SUBJECT: PRODUCT ALERT for Whirlpool 90% dedicated horizontal gas furnaces.

MODELS: All WFCH series units.

The model and serial number listed below has been inspected as outlined in Armstrong Service Bulletin WSVB03-6.

Figure 1

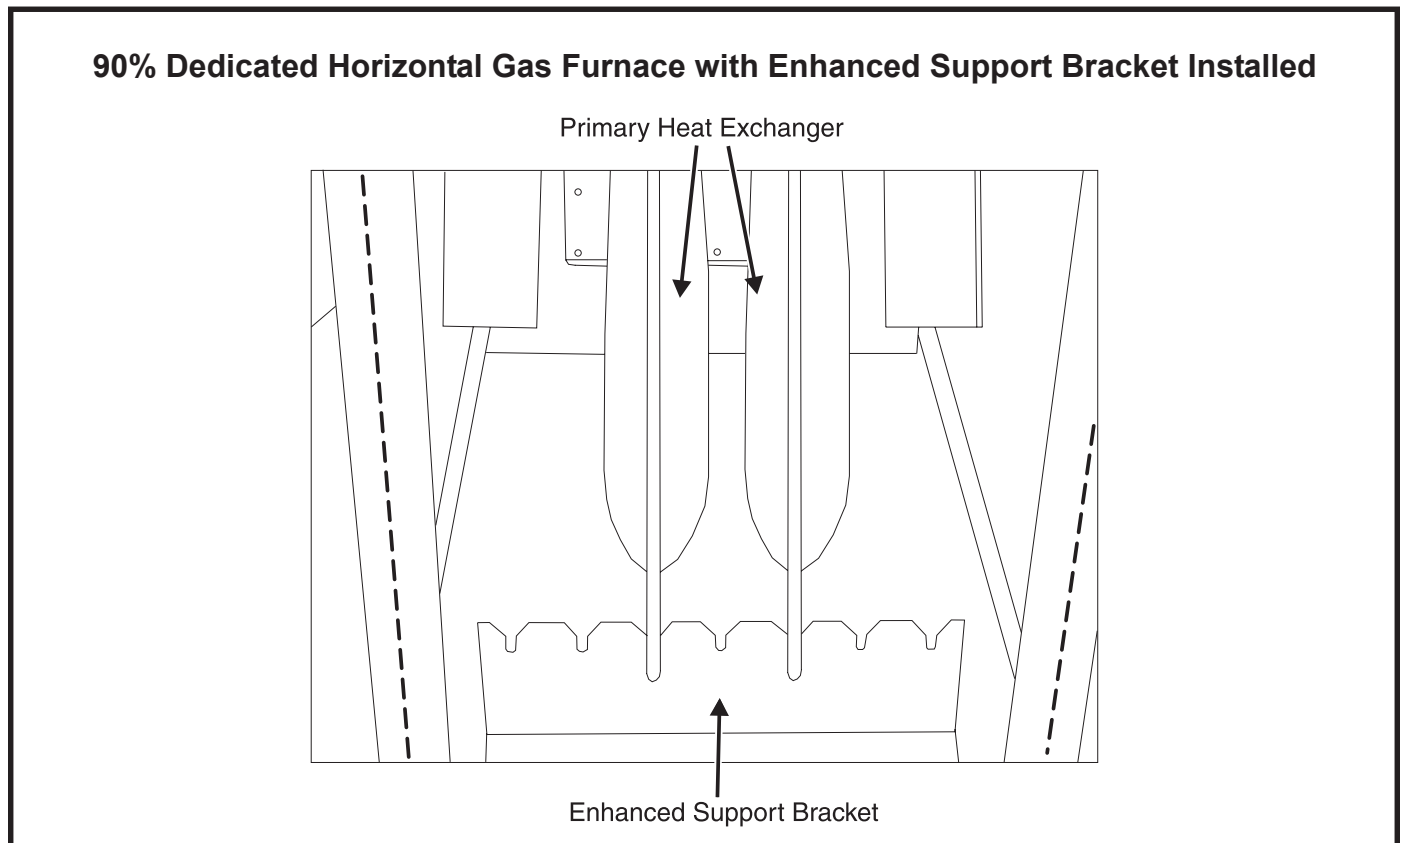
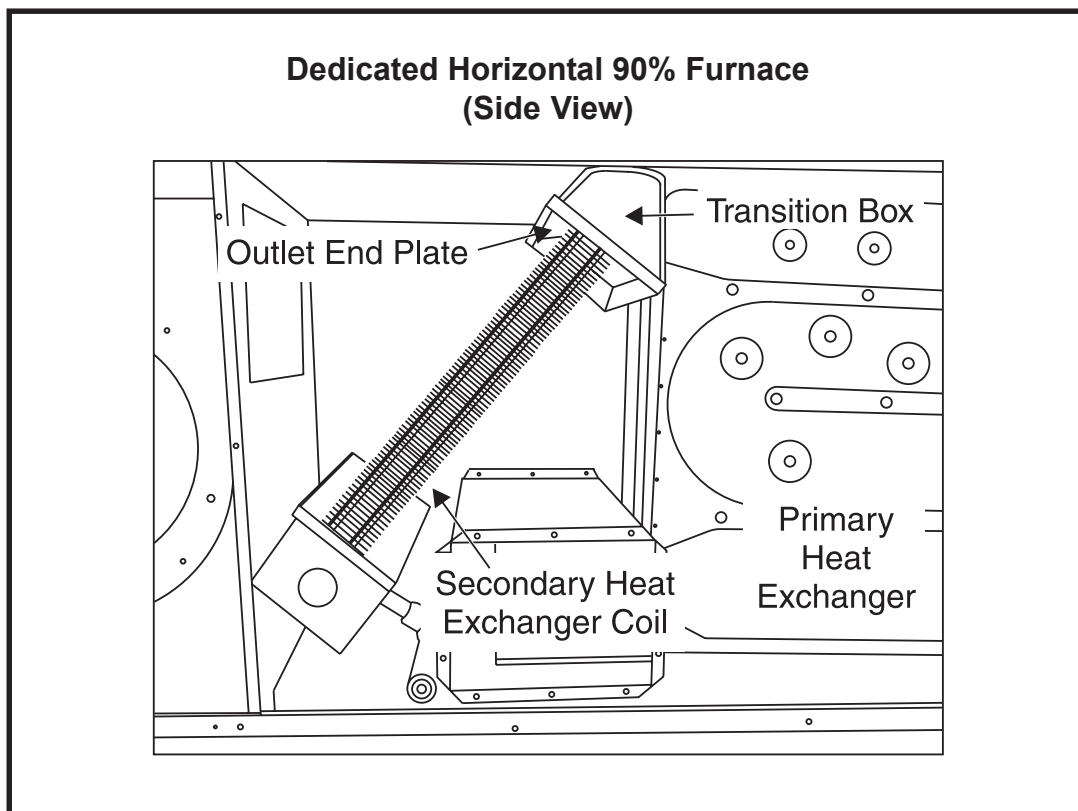
FACTORY CORRECTIVE ACTION: All product produced by Armstrong after November 1, 2003 (beginning with serial number 8403L) will contain an enhanced support bracket. Any product produced before November 1 (serial number 8403K and prior) that has been corrected can be identified by the "Bracket Installed" label on the carton.

All WFCH units which have not been installed and do not have the "Bracket Installed" label on the carton must be returned to you participating distributor. From this point on, do not install any WFCH units that do not have the enhanced support bracket installed as shown in Figure 1.

Figure 4

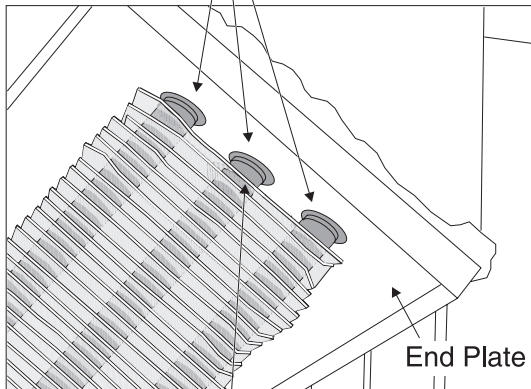
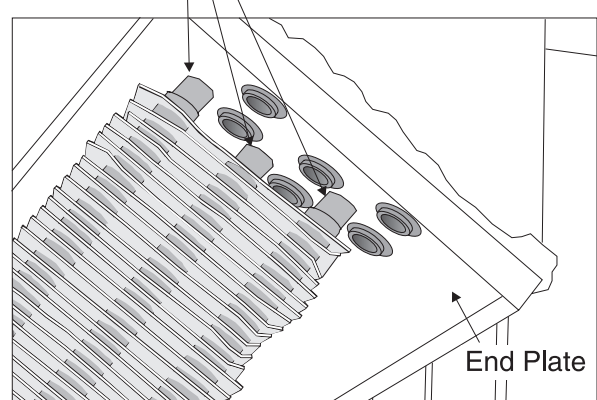
4. See Figure 4 to aid in determining the integrity of the secondary heat exchanger and the outlet end plate connection. If separation has occurred, the unit must remain shut down. Remove the unit from service and replace with a new unit. Contact your participating distributor to obtain a new unit and appropriate warranty paperwork.

Secondary heat exchanger tubes properly attached to plate

Top fin of secondary heat exchanger should be no more than 1/4" from endplate.

Secondary heat exchanger tubes separated from plate

Figure 5

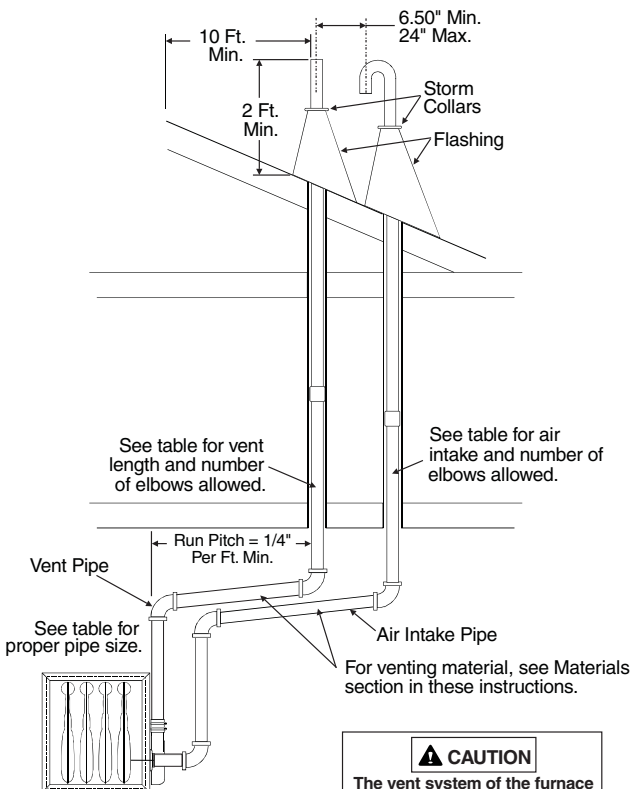
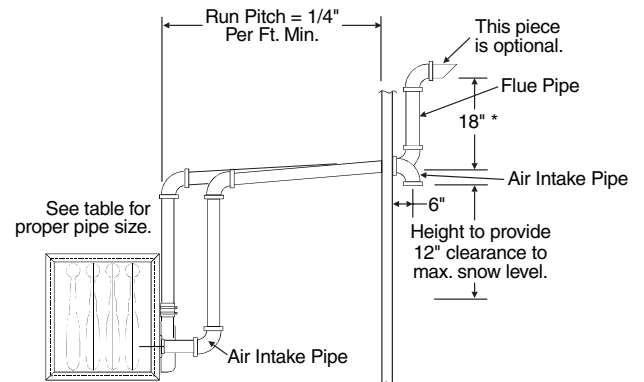
5. If the heat exchanger/transition box end plate connection is intact, re-install the main limit control removed in Step 2.
6. Ensure that the unit is properly vented and that the combustion air intake pipe meets the minimum length requirement of 5 feet (see Figure 5).

CAUTION
The vent system of the furnace must be self-supporting and must not apply any weight load to the combustion blower.

NOTE:
Do not cement air intake pipe into the connector on the burner box. Use high temperature RTV silicone sealant so that intake pipe can be removed if service is required.
